**Historic Review**

**Staff Report for a Single Family Home and Detached Garage/ADU in the Canemah Historic District  
October 16, 2018**

- FILE NO.:** HR 18-11: Historic Review Board review of a new single family home and detached garage with upper floor accessory dwelling unit in the Canemah National Register Historic District.

*Rendering from 4<sup>th</sup> Avenue*

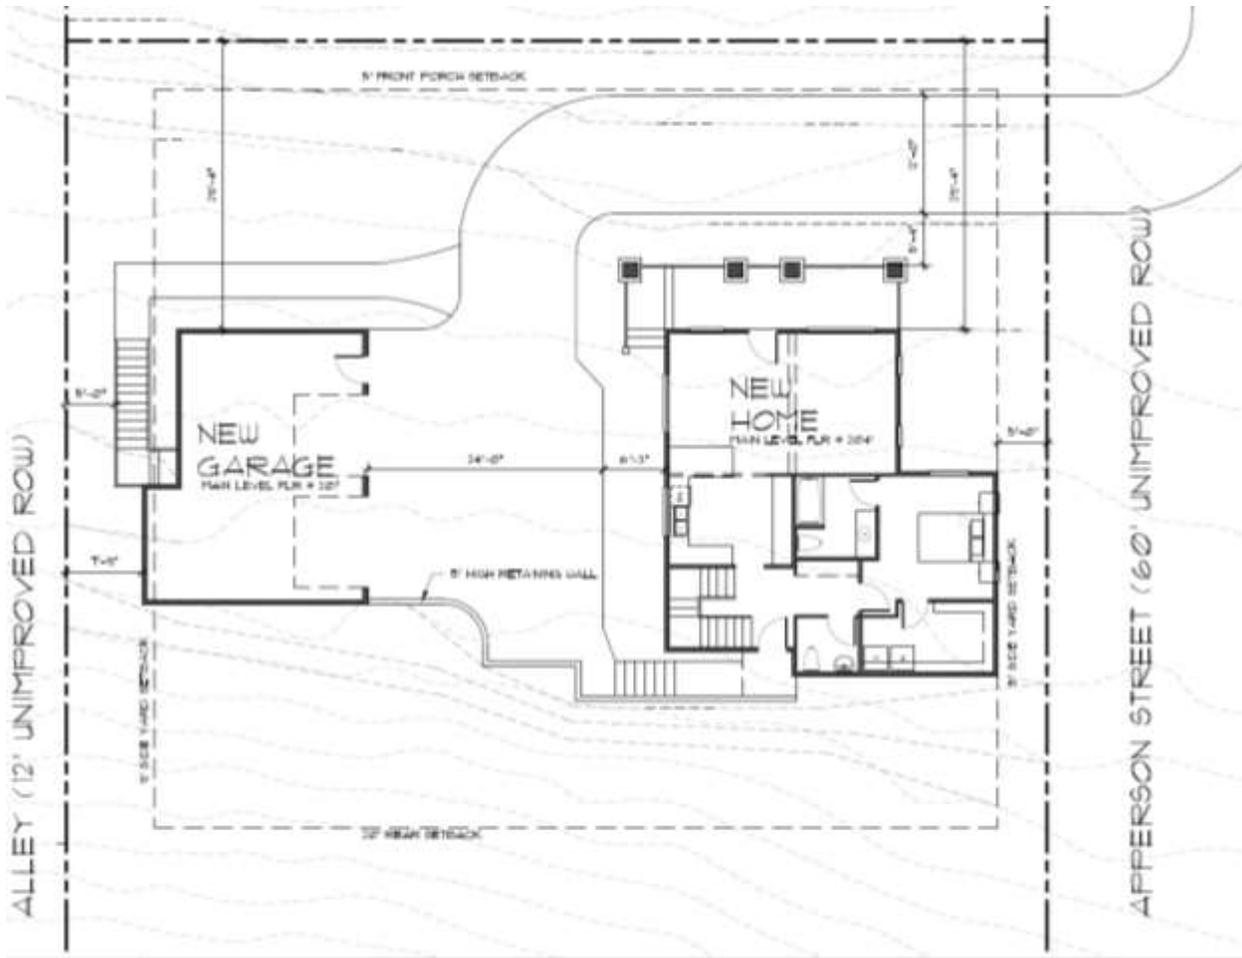
The applicant submitted renderings which demonstrate that the home will be minimally visible from 4<sup>th</sup> Avenue, when viewing the contributing structure, the A.E. Davis Residence (see Exhibit 4), which is located in front of the proposed home. Farther down on 4<sup>th</sup> Avenue toward the east, renderings demonstrate that the structures will be more visible, however, there are factors which mitigate this, which are discussed in the staff report. Staff is also looking for direction from the Board on the impact of

The context of the A.E. Davis Residence is natural surroundings with no other structures in direct view when viewing the home from 4<sup>th</sup> Avenue. This proposal includes 24-foot tall and 22-foot tall structures behind the historic home. The applicant submitted renderings which demonstrate that the home will be minimally visible from 4<sup>th</sup> Avenue, when viewing the A.E. Davis Residence. The second level of the garage/ADU structure is visible when viewing the A.E. Davis Residence. The front door and windows of the ADU are mostly obscured by the terrace wall. Staff is looking for direction from the Board on the impact of the garage/ADU design.

Farther down on 4<sup>th</sup> Avenue toward the east, renderings demonstrate that the structures will be more visible and prominent, however, there are factors which mitigate this:

First, the applicant's renderings demonstrate that the appearance of the detached garage /ADU is minimized due to its placement on the lot and distance from the street. Only the top story is visible from this perspective.

Second, while, the home is prominent from this perspective, it does not impact the view of the front of the A.E. Davis Residence. The view of the A.E. Davis residence is the side view here, and the portion of the house that is most in the line of vision is the rear addition which is not part of the significance of the structure.

The applicant shall also add landscaping in front of the home and garage to eventually provide a visual barrier behind the A.E. Davis Residence. The landscaping shall include five large native tree species and five shrubs, with final locations to be determined by staff upon a site visit once the house is under construction.

Front elevation: house

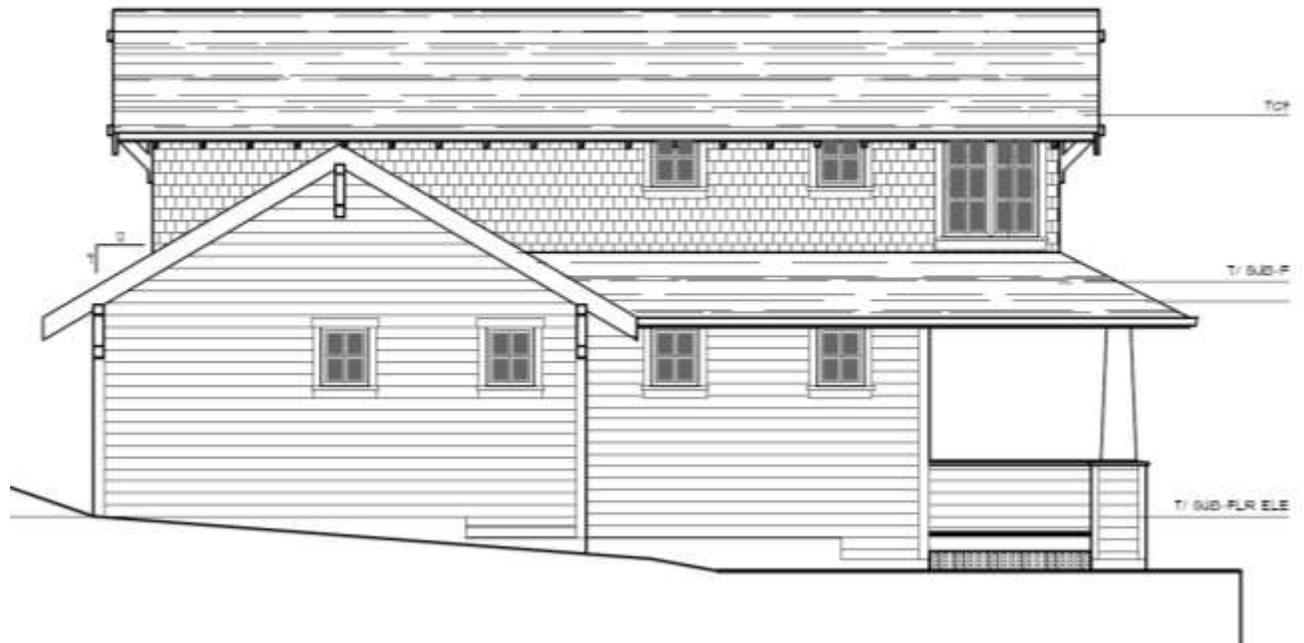
The front façade is asymmetrical due to window variation and left side wing, and the front porch is symmetrical. The front porch utilizes a hip roof and wraps around the right side of the home to meet the driveway at grade. The design utilizes overhanging eaves, exposed rafter tails, and decorative knee brackets, which are all typical of the bungalow style. An earlier version of the design included a second story porch. Public comments were received questioning the compatibility of the second story porch. The design was revised after the August 28, 2018 hearing to enclose the second level porch and extend the first story front porch so that the second story would be recessed.

Latticework is proposed under the front porch due to the upsloping site. For the latticework under the front porch, the applicant shall use 90 degree perpendicular wood lattice or other architectural styles appropriate for house, painted either to match the color of the house or to blend in with the surroundings. Exposed lattice proposed under the front porch shall not be more than one foot taller than shown in plans. Any changes exceeding one feet must be reviewed by the Historic Review Board.

3. For the latticework under the front porch, the applicant shall use 90 degree perpendicular wood lattice or other architectural styles appropriate for house, painted either to match the color of the house or to blend in with the surroundings. (P)

4. Exposed lattice proposed under the front porch shall not be more than one foot taller than shown in plans. Any changes exceeding one foot must be reviewed by the Historic Review Board. (P)

Front elevation: garage

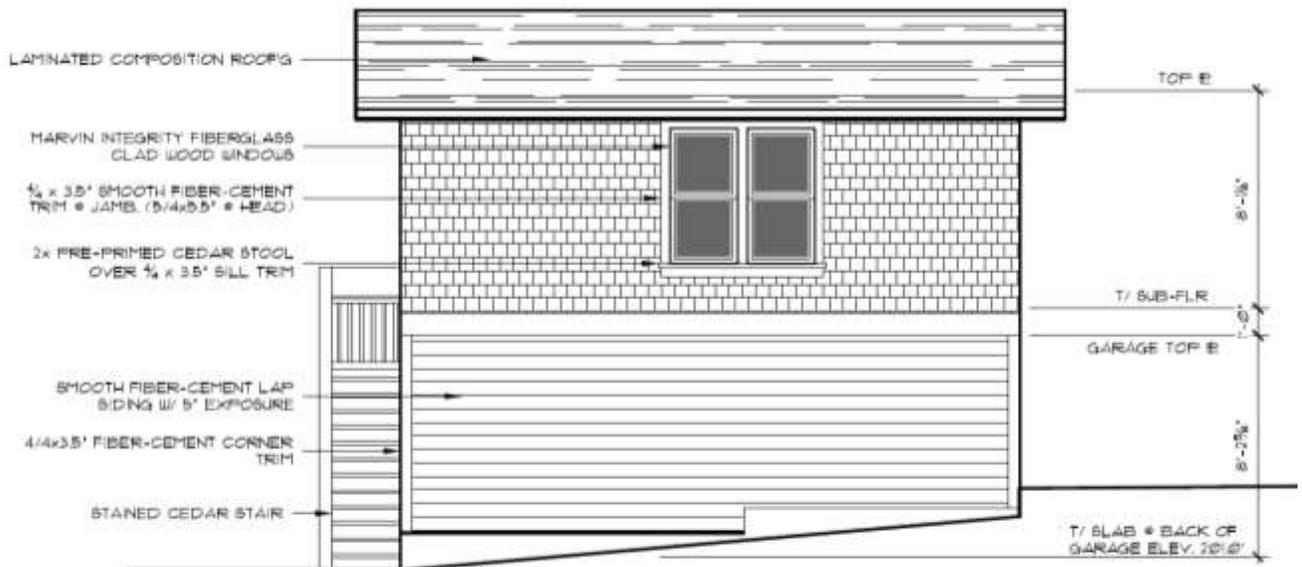
The proposed detached garage/ADU is two stories; a garage with a very small one story dwelling on top. The ADU is accessed by an exterior stair on the side of the building that leads to a large terrace over the garage and a front door facing the street. A public comment about the detached garage/ADU questioned the compatibility of the large upper level terrace and the exterior stair. The upper level terrace is an element found in the City's historic districts, but it has not been combined with an ADU or living space over a detached garage in this way. The applicant's renderings demonstrate that the appearance of the detached garage /ADU is minimized from the east view due to its placement on the lot and distance from the street. Only the top story is visible from this perspective. The exterior stair is not visible from the street, as demonstrated by the renderings. From the west side of the A.E. Davis residence, the structure is more visible. The second level of the garage/ADU structure is visible, and the front door and windows of the ADU are mostly obscured by the terrace wall. Staff is looking for direction from the Board on the impact of the garage/ADU design.

Public comment about the detached garage/ADU questioned the compatibility of the large upper level terrace and the exterior stair, purported that the design detracts from the district, and suggested that

- Add window(s) on the right side of the entry
- Utilize a front gable roof rather than side gable
- Make the front façade of the ADU more visible rather than obscuring it from view with the terrace wall
- Move the stair farther to the rear of the structure so that it is less visible from 4<sup>th</sup> Avenue

9. The applicant shall provide visual screening of two large shrubs with at least 5 foot mature height and one tree with at least 25 feet mature height planted between the proposed ADU and the property line. (P)
